# Administrative Approval Action

AA # 3926 / SR-73-18, Sojourn Glenwood Place  
Transaction# 564929

<b>PROJECT</b>	<b>Project Name</b>	Sojourn Glenwood Place Phase II	
	<b>Development Case Number</b>	SR-73-18	
	<b>Transaction Number</b>	564929	
	<b>Design Adjustment Number</b>	DA - 123 - 2018	
<b>STAFF RESPONSE</b>	<b>Staff recommendation based upon the findings in the applicable code(s):</b>		
	<input type="checkbox"/> UDO Art. 8.3 Blocks, Lots, Access	<input type="checkbox"/> UDO Art. 8.5 Existing Streets	
	<input type="checkbox"/> UDO Art. 8.4 New Streets	<input checked="" type="checkbox"/> Raleigh Street Design Manual	
	Staff <b>SUPPORTS</b> <input checked="" type="checkbox"/> <b>DOES NOT SUPPORT</b> <input type="checkbox"/> the design adjustment request.		
	<b>DEPARTMENTS</b>		
	<input type="checkbox"/> Dev. Services Planner	<input type="checkbox"/> City Planning	
	<input checked="" type="checkbox"/> Development Engineering	<input type="checkbox"/> Transportation	
	<input type="checkbox"/> Engineering Services	<input type="checkbox"/> Parks & Recreation and Cult. Res.

**DRIVEWAY EXHIBIT**

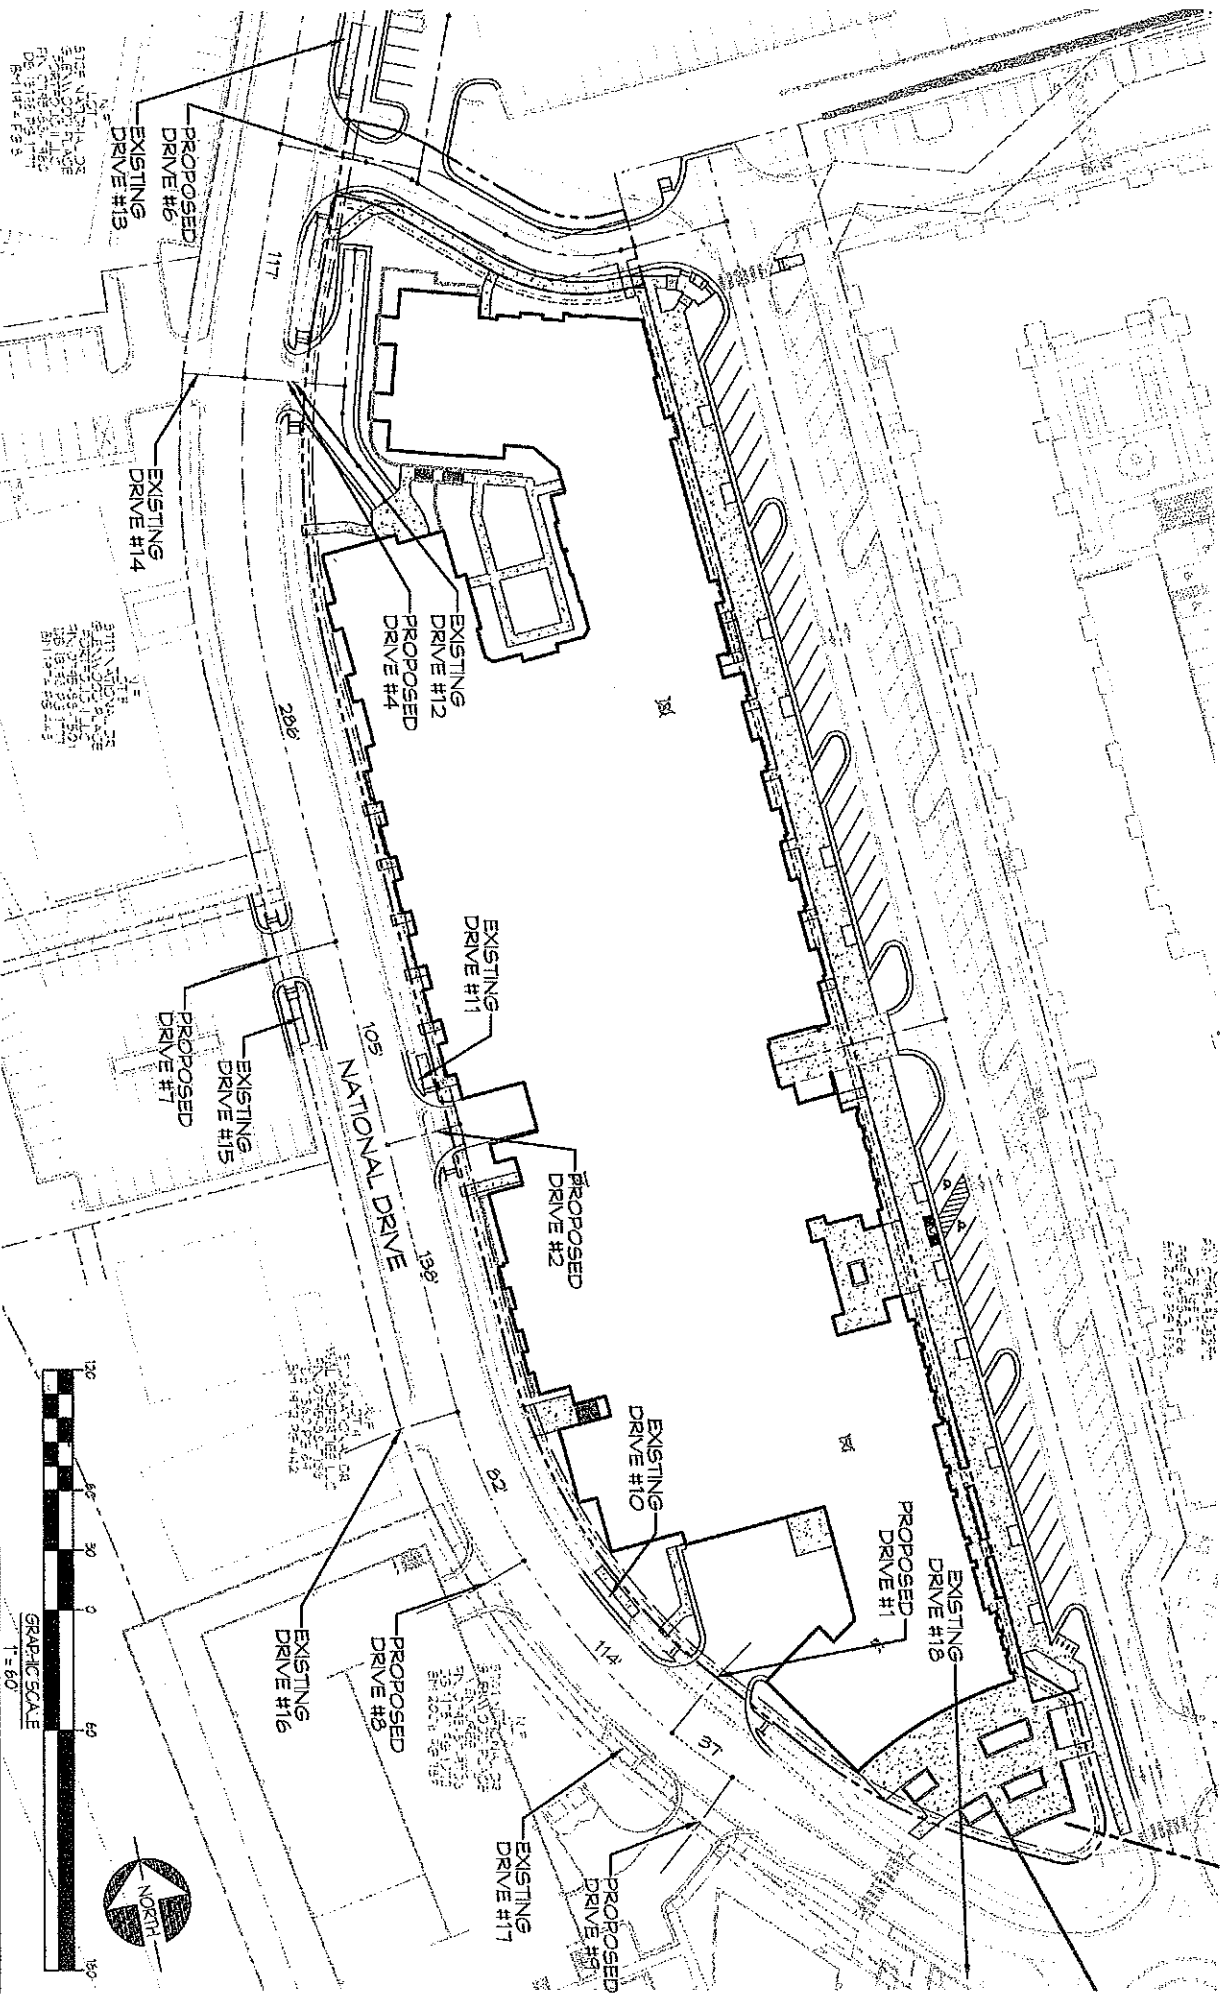
Please refer to the Driveway Exhibit included in this request.

Proposed Driveway 1 is a service drive that provides access for service and delivery vehicles to the service area of the proposed retail uses in the building. The vehicles accessing this drive will be primarily waste and recycling pick up, and food service delivery vehicles. The retail use typically restricts deliveries to off peak hours so the use of this drive will be very limited in both the number of trips and the timing of those

trips. Most of the drivers will be commercially licensed operators. This Proposed Driveway 1 is approximately 37 feet north of Proposed Driveway 9 which will serve as one of two entrances to the parking deck of 3800 Glenwood Avenue, SR-55-18 on the opposite side of National Drive. Due to the shape of the existing lots fronting the roundabout, and the UDO build to requirements, the locations of the proposed buildings on this lot and the 3800 Glenwood Avenue lot create a significant site constraint. There is also a significant grade change along this section of National Drive that requires drive access to 3800 be made at certain locations in order to match the elevations of each level of the parking deck. The separation between Proposed Drive 1 to Sojourn Glenwood Place Phase II and Proposed Drive 9 to 3800 Glenwood is approximately 114 feet, exceeding the 100 foot minimum. It should also be noted that within the existing development there is only a 55 foot separation between Existing Driveway 10, serving the existing office uses on the Sojourn site, and the opposing Existing Driveway 17, which served the office uses that were on the 3800 Glenwood site. Both of these existing drives, which are to be closed, were full service drives that provided access to a significant number of vehicles. Given the existing conditions and the very limited use of the Proposed Driveway 1, we believe that the intent of the Raleigh Street Design Manual is being met with this proposal.

Proposed Driveway 2 is one of two drives into the parking deck for Sojourn Glenwood Place Phase II. The other is on Exchange Glenwood Place. Proposed Driveway 2 is located approximately 138 feet from Existing Driveway 16, an existing opposing driveway to the south, and approximately 72 feet south of Existing Driveway 15, an existing opposing driveway to the north. To improve this separation, we are proposing to relocate Existing Driveway 15 approximately 30 feet north at Proposed Driveway 7, to provide access to the existing surface lot and create a 105 foot separation between Proposed Driveway 2 and Proposed Driveway 7. It should also be noted that the current separation between Existing Driveway 11 and Existing Driveway 15 is only approximately 46 feet. These existing drives are both full service, opposing drives that serve significant surface parking areas. We believe that this existing condition will be improved by our proposed redevelopment.

Proposed Driveway 4 is also to provide access to a service area for trash and recycling pick up and move in access, loading and unloading for residents. This service area will generate very few trips, and those will typically be off peak trips and a majority will be commercially licensed operators. Driveway 4 aligns with the opposing Existing Driveway 14 on the other side of National Drive. The separation between Proposed Driveway 4 and Proposed Driveway 6, Tucker Oaks Lane, is approximately 117 feet.

The separation between Proposed Driveway 4 and Existing Driveway 7 is approximately 286 feet.

Existing Driveway 10 will be closed and replaced by Proposed Driveway 1 for deliveries, solid waste and recycling pickup for the proposed retail and restaurant uses.

Existing Driveway 11 will be closed and replaced by Proposed Driveway 2 increasing the driveway separation above the existing condition.

Existing Driveway 12 will be closed and replaced with Proposed Driveway 4 and 5 for the move in, solid waste and recycling pickup.

Existing Driveway 13 will be closed and replaced with Proposed Driveway 6, an alley that will connect to Exchange Glenwood Place.

Existing Driveway 14 will remain as is.

Existing Driveway 15 will close and be replaced by Proposed Driveway 7 increasing the driveway separation above the existing condition.

Existing Driveway 16 will remain as is.

Existing Driveway 17 will be closed and replaced by Proposed Driveway 9.

Existing Driveway 18 will be closed.

In summary, given the limited use of Proposed Driveways 1 and 4, along with the relocation of Existing Driveway 15 to Proposed Driveway 17, and the closing of Existing Driveways 10, 11, 12, 13, 15, 17 and 18, we believe this design creates a functional and safe series of drives that meets the intent of the Raleigh Street Design Manual.

Staff supports the request for relief regarding driveway spacing of >100' per the Raleigh Street Design Manual 3.2.3.A for the Avenue 2-Lane, Undivided street section. The closure of existing driveways, relocation of one opposing driveway, alignment of opposing driveways in one location, and the shift that eliminates conflicting left turns in one instance at a location where peak uses differ show that they meet the intent of the driveway spacing requirement. The only driveway being proposed that does not meet the 100' driveway spacing is a service driveway across from a proposed parking deck entrance. This location cannot be aligned due to grade constraints and the offset of the two driveways is done in such a way that a non conflicting left turn is created.
